Stormwater Review By:
Mohammad Rahman, PE, PH, CFM
Phone 480-312-2563 Fax 480-312-7781
e-mail: mrahman@scottsdaleaz.gov
Review Cycle #1 Date 6/24/16

PRELIMINARY PLAT
SCOTTSDALE, ARIZONA

ALTA / NSPS LAND TITLE SURVEY LOTS 2 AND 3 OF CROSSROADS

NEC SCOTTSDALE ROAD AND CHAUNCEY LANE
EXISTING CONDITIONS GRADING PLAN

PP1
1 OF 1 SHEETS

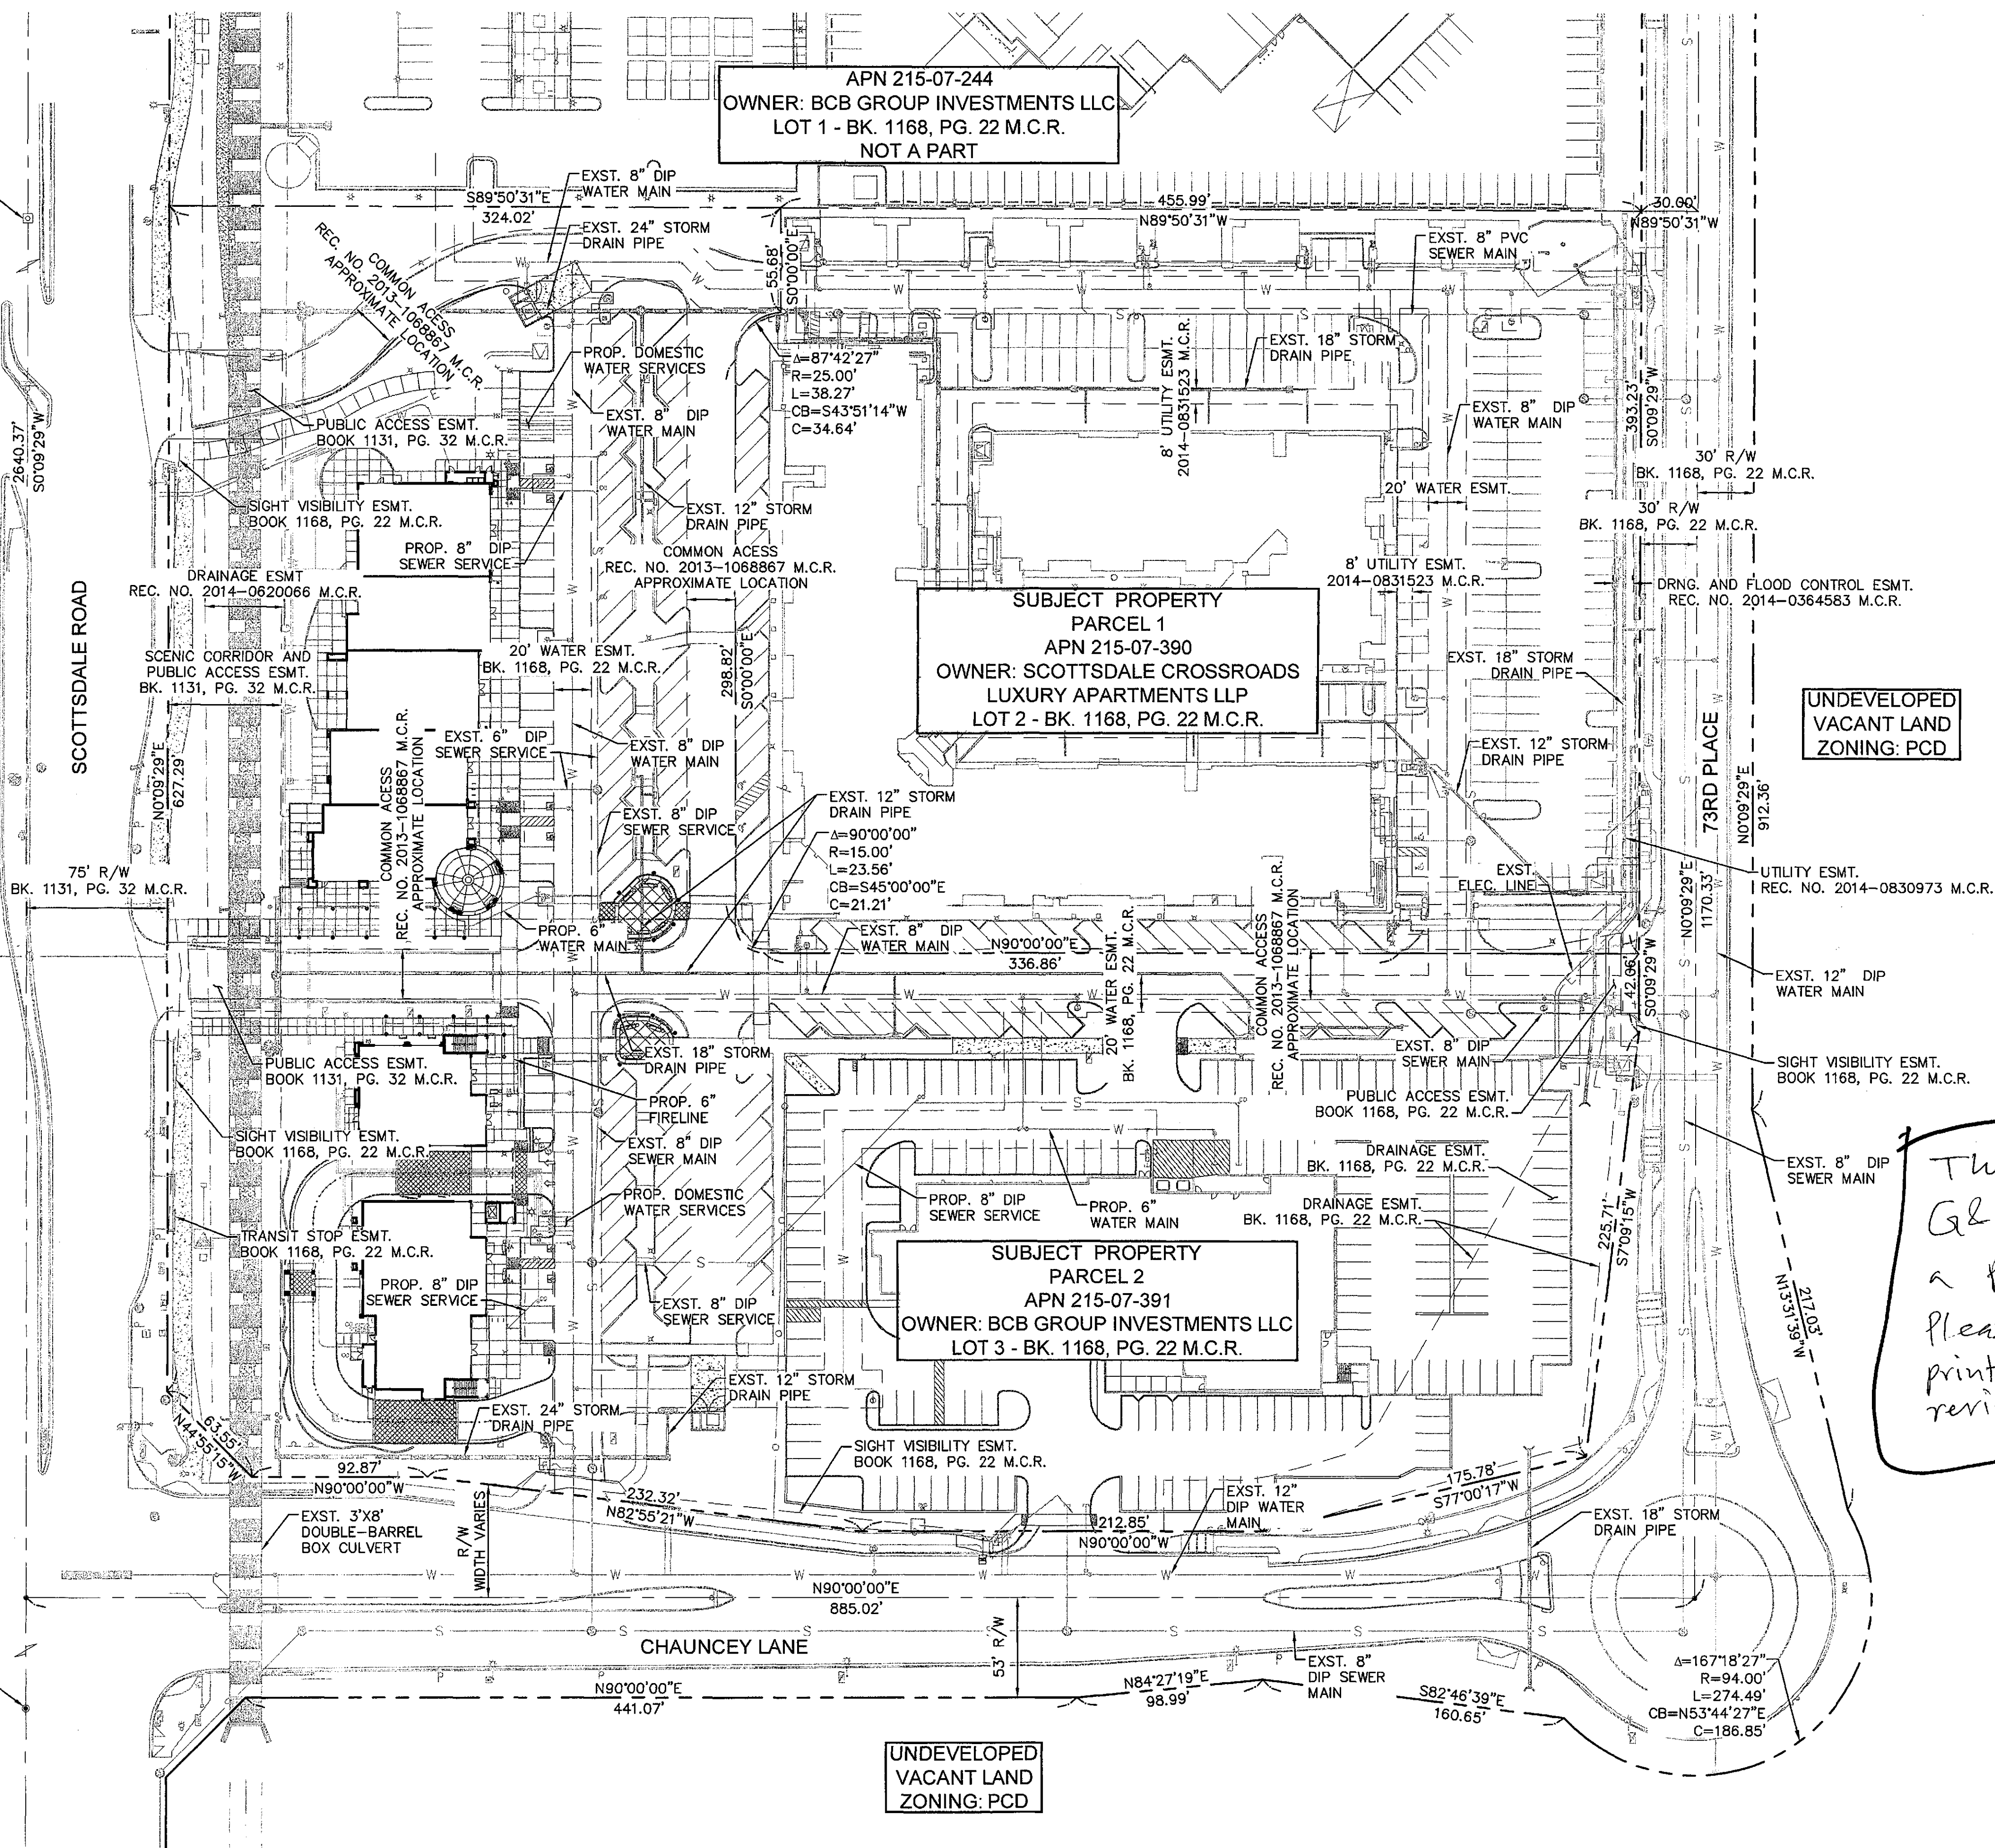
This is a Conceptual
G&D plan and not
a Preliminary Plat.
Please the attached
printouts for detail
review comments.
